AMPLIFIER FAILURE DUE TO WATER INGRESS

F87 (M2)			
----------	--	--	--

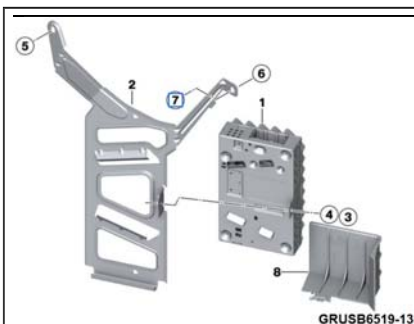
In this picture from the parts catalogue ETK, the amplifier (number 1) is to be replaced as described in this bulletin.

In conjunction, the splash shield (number 8) is to be installed.

Replace the audio amplifier and install the part number for the only in conjunction with spray guard (splash shield) if it has not already been installed.

Here is the amplifier installed in the vehicle:

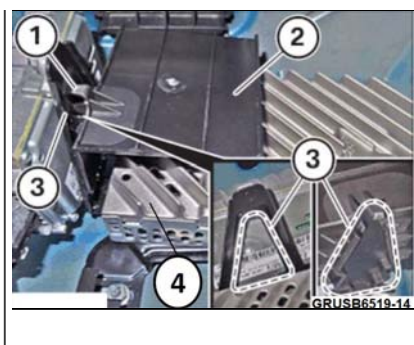
- 2. – splash shield
- 3. – holder for the splash shield
- 4. – amplifier
